**Land Use Control
Remedial Design/Remedial Action Work Plan
IR Site 30**

**NAVAL STATION TREASURE ISLAND
SAN FRANCISCO, CALIFORNIA**

APPENDIX C
RESPONSE TO COMMENTS

Draft Land Use Control Plan, IR Site 30, Naval Station Treasure Island, San Francisco California

FIGURE 2
SITE VICINITY MAP

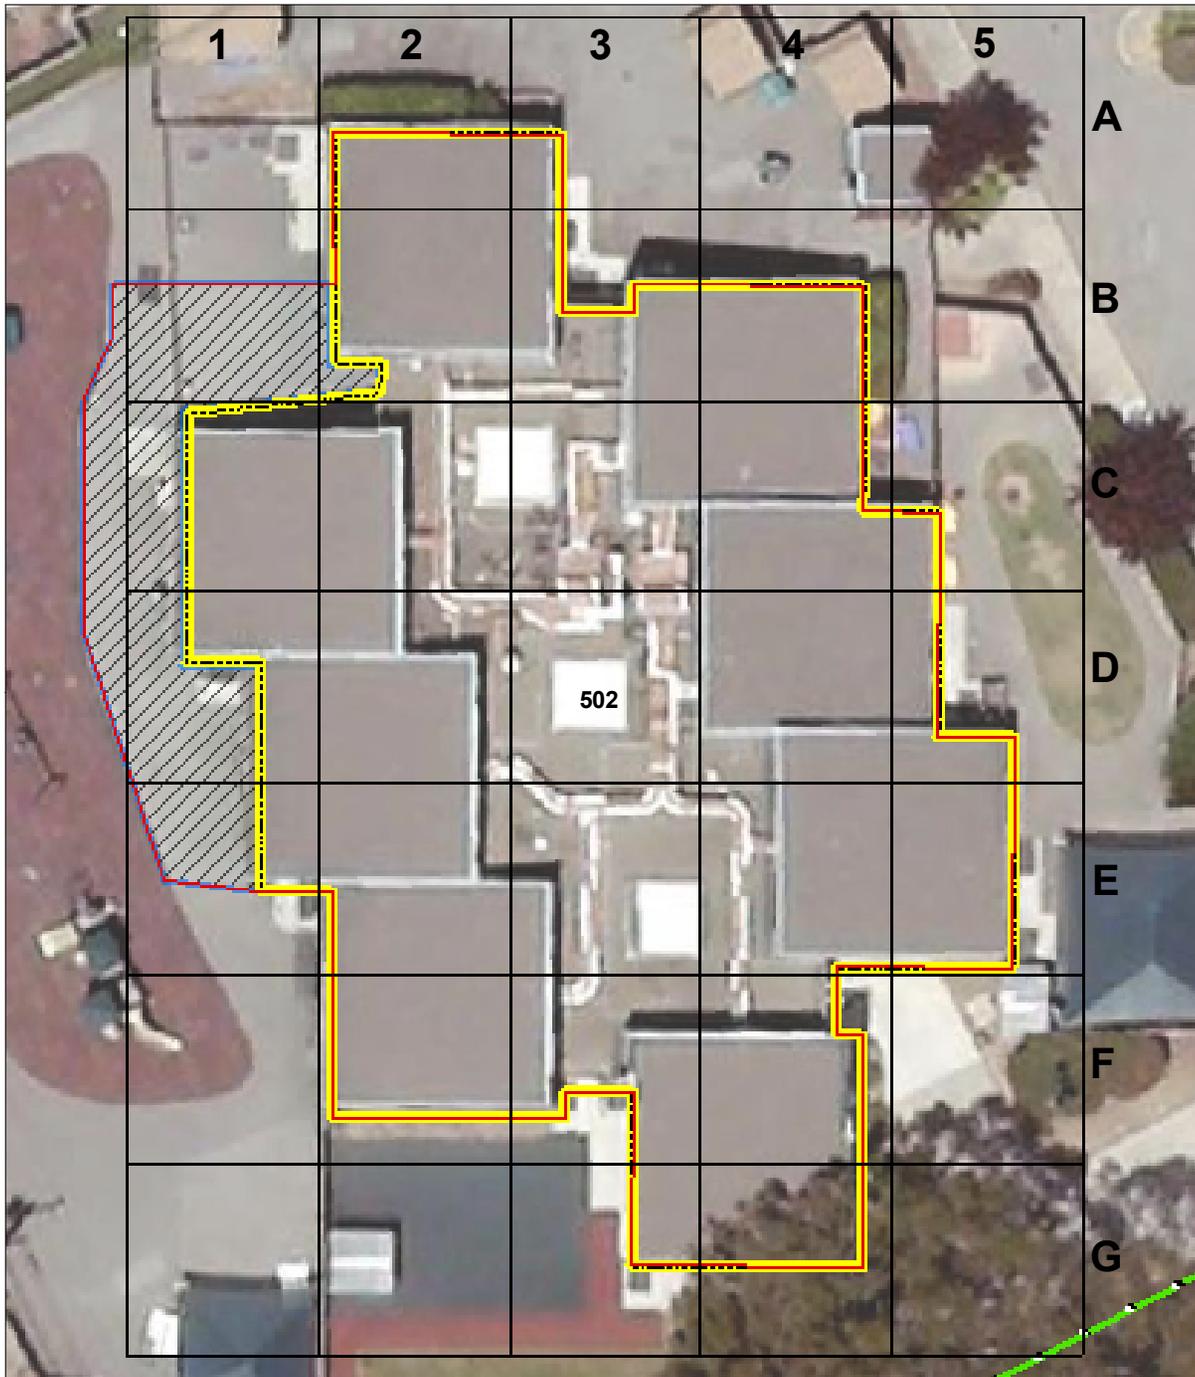
5.	<p>Figure 2 (Site Vicinity Map) – The red boundary line appears to be mistakenly labeled as the Site 30 boundary line rather than the Building 502 boundary line. Please correct this and add a Site 30 boundary line</p>	<p>Figure 2 has been revised to identify the boundary of IR Site 30 along Building 502. Figure 2 is consistent with Figure 2 of the ROD. A hatched pattern has been added to delineate the concrete pad (see DTSC Specific Comment 8.2)</p>

<p>Figure 2 This figure shows the Site 30 boundary as being the outline of Building 502. The figure should be revised to show the correct site boundary (consistent with the description in Section 2.1).</p>	<p>Figure 2 has been revised to show the correct boundary of IR Site 30.</p>
<p>Appendix A (IR Site 30 Field Inspection Checklist) and Appendix B (IR Site 30 LUC Annual Compliance Monitoring Report). Both documents request the inspector to assess and report whether there has been any removal or damage to security features such as locks on site fencing, signs, survey monuments, or other appurtenances. Because such security features are not a component of the selected remedy, we request removing this item from the documents.</p>	<p>Security features, while not mentioned specifically in the ROD, are part of the selected remedy in that they provide an extra layer of protection by helping keep unauthorized persons and activities away from the Building 502 concrete slab.</p>

8	<p>Figure 2 - Site Vicinity Map 8.1 The Site 30 boundary in the ROD includes the area bounded by Avenue E, Avenue O, 10th Street and 11th Street. Figure 2 should be revised to be consistent with the ROD and the legend for the area labeled as "Site 30 Boundary" should be change to "LUC Area" or "Remedial Action Area" per the ROD.</p> <p>8.2 Please label Building 502 and add hatch lines or other marks for the concrete pad area to clearly see the area in a black and white copy.</p>	<p>Figure 2 has been revised to be consistent with the ROD and the legend has been revised to indicate the "LUC Area."</p> <p>Figure 2 has been revised to include hatch lines to indicate the location of the concrete pad.</p>
9	<p>Appendix A - Field Inspection Checklist</p> <p>9.1 The LUC Checklist and the Field Inspection Checklist include a "Location No." column. A figure with gridlines (e.g. 25 feet by 25 feet) in the LUC Area and grid numbers should be prepared and included in the RD/RAWP. The specific grid number should be identified under Location No. in the inspection form.</p>	The Appendix A – Field Inspection Checklist has been revised to include a "Location No." column. Figure 3, Building 502 Inspection Map, has been added to Appendix A. This number refers to the numbered grid shown on Figure 3 (e.g. A4). This number will be recorded in the "Location No." column and the area of damage will be indicated on the figure.
